# 11 ZON2013-01601

#### PLANNED UNIT DEVELOPMENT

STAFF REPORT Date: August 8, 2013

**DEVELOPMENT NAME** USA Management, LLC

# SITE PLAN

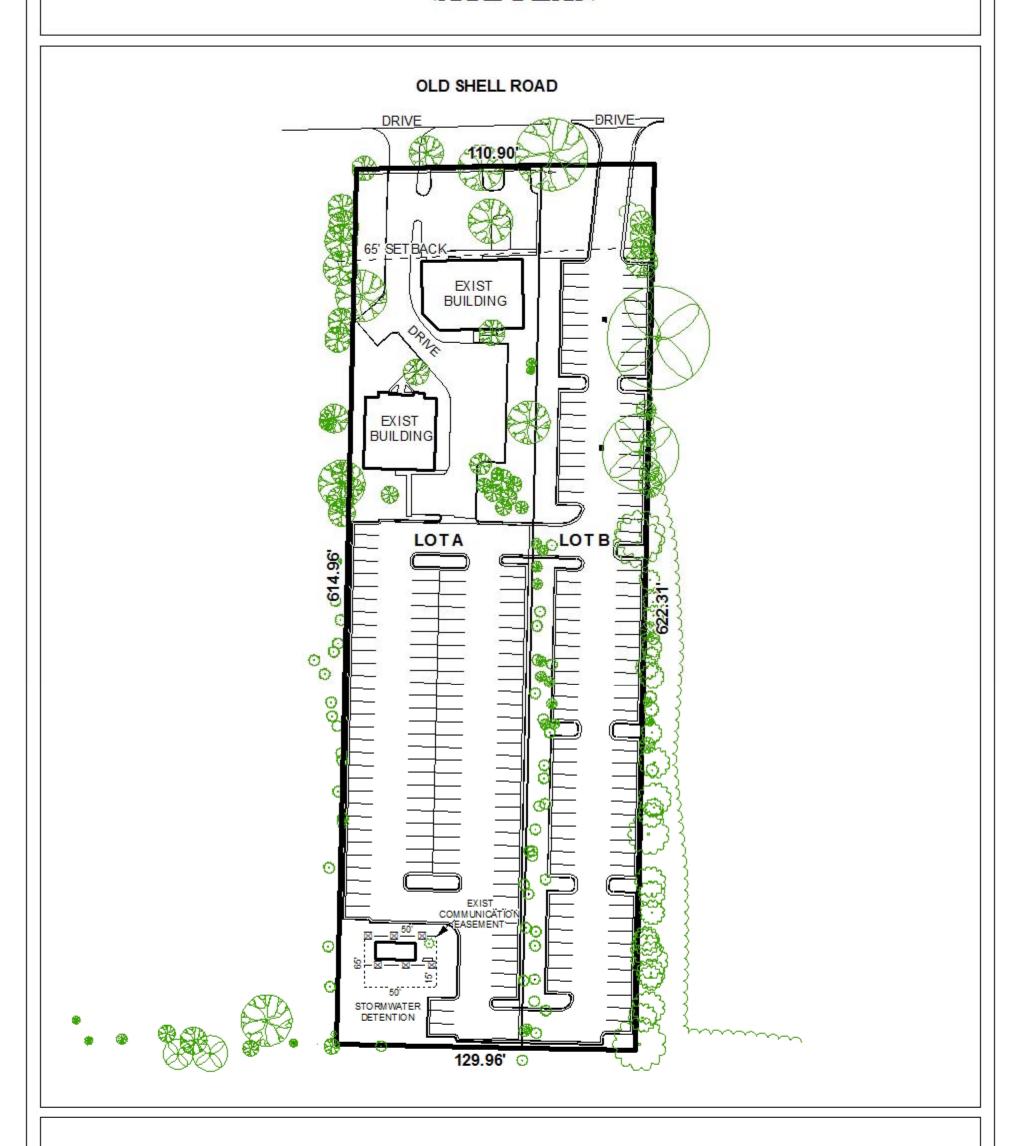
There is no dumpster illustrated for the office site, nor is there a note stating that curbside pickup will be utilized. If approved, the site plan should be revised to illustrate a dumpster compliant with Section 64-4.D.9.c. of the Zoning Ordinance, or include a note stating that curbside pickup will be utilized.

The site plan illustrates the compliant amount of total landscaping; however, applicant provides no tree plan or any calculations for the number of trees required. The proposed plan does illustrate several trees that may be taken for credit. Therefore, if approved, a condition of the approval should be full compliance with the landscaping and tree requirements of the Zoning Ordinance. The parking lot on Lot A should be revised to provide landscape areas similar to the proposed landscape aisles on Lot B.

As mentioned in the Traffic Engineering comments, due to the substandard driveway and parking aisles surrounding the existing commercial buildings, access to the proposed new parking on Lot A & Lot B should be limited to the new driveway on Lot B. Therefore, a barricade or the closure of the access way from the parking lot and the existing offices on Lot A, should be required. In addition, no sidewalks are illustrated on the site plan along both lots;

therefore, the site plan should be revised to illustrate the sidewalks along Old Shell Road for the development.

It should be noted that the site has R-1, Single Family Residential property adjacent to the West and South of the site. An eight-inch block wall is illustrated along the Western property line of Lot A, but no note stating the height of the wall. No fence is illustrated along the South property line of Lots A and B. The site plan should be revised to illustrate either a 6' high privacy fence, or a 6' high 10' wide evergreen vegetative buffer in compliance with Section 64.4.D.1. of the Zoning Ordinance for the development.

- 3) a barricade or closure of the access way from the parking on Lot A to the existing offices;
- 4) the placement of sidewalks along Old Shell Road for the entire development;

- 5) the revision of the site plan to provide landscape aisles on Lot A similar to the design as proposed on Lot B;
- 6) revision of the site plan to illustrate a dumpster compliant with Section 64-4.D.9.c. of the Zoning Ordinance, or to include a note stating that curbside pickup will be utilized;

- 7) revision of the site plan to illustrate either a 6' high privacy fence, or a 6' high 10' wide evergreen vegetative buffer in compliance with Section 64.4.D.1. of the Zoning Ordinance for the development; and
